DEPARTMENT OF NATURAL RESOURCES

MISSOURI DEPARTMENT OF NATURAL RESOURCES
REPORT OF INSPECTION
COMMUNITY PUBLIC WATER SYSTEM
KIMBERLING CITY WATER COMPANY
STONE COUNTY, MISSOURI
PUBLIC WATER SYSTEM ID NUMBER MO5036046

July 6, 2012

Location: Kimberling City Water Company
Photographer: Bailey Pearson
Photograph Date: June 21, 2012
Comments: Well head with chlorine injection port

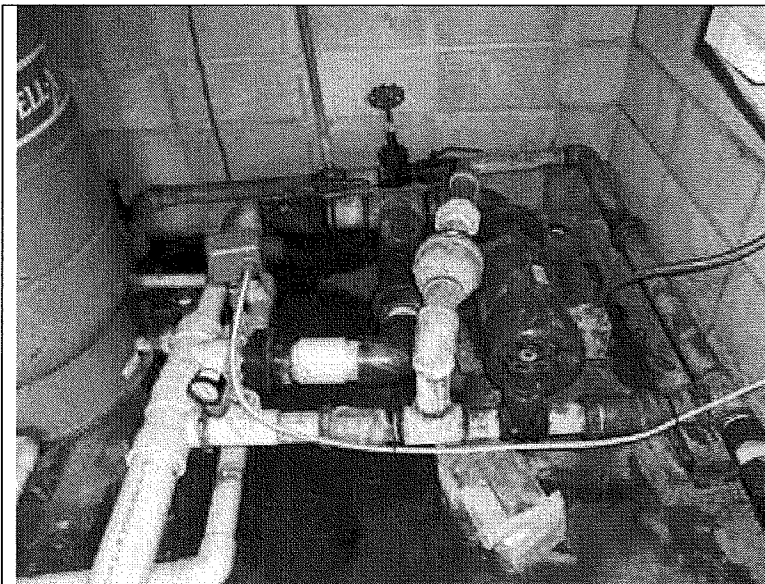
11. The well casing was not protected against physical damage.

The well casing and discharge piping must be protected against deterioration, physical damage, and freezing. Paint protects the metal casing from corrosion. An insulated well house prevents freezing.

The Department recommends painting the exterior of the well casing and discharge piping.

Location: Kimberling City Water Company
Photographer: Bailey Pearson
Photograph Date: June 21, 2012
Comments: One high service booster pump and piping to storage tank

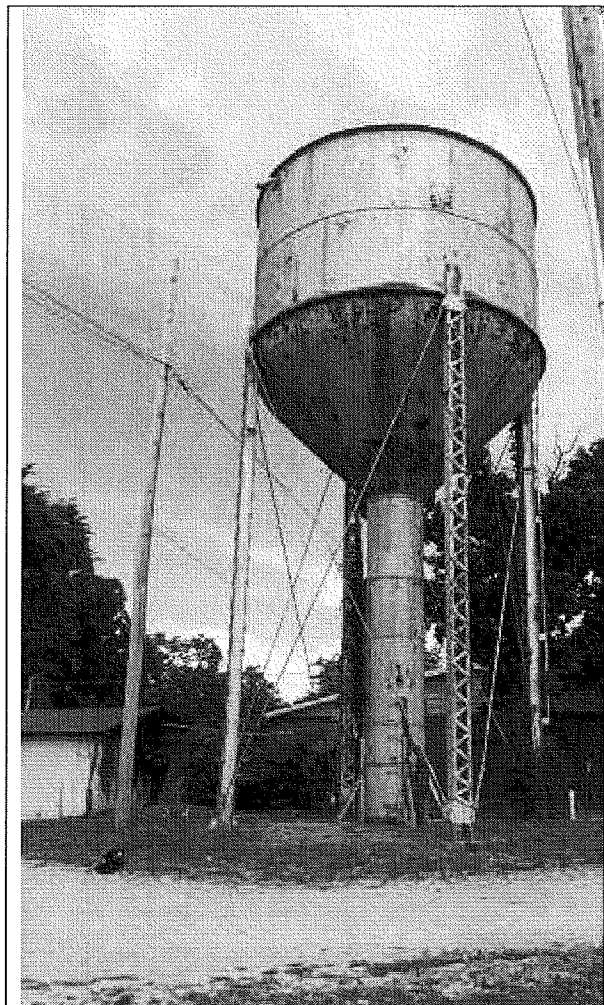
9. Duplicate high service pumps are not provided. This was cited during the previous inspection.

10. The booster pump is not sufficiently valved to permit bypassing. Specifically, there are not valves on the inlet and outlet piping to the booster pump.

Booster pumps should and piped to allow pumps to be taken offline and repaired without causing a loss of pressure in the distribution system. This shall include sufficient valves to the storage tank to permit continuous operation of the system even with the booster pump offline.

The Department recommends installing duplicate high service pumps.

The Department recommends installing the necessary valves on the inlet and outlet piping to the booster pump to allow it to be taken offline without causing a loss of pressure in the distribution system.
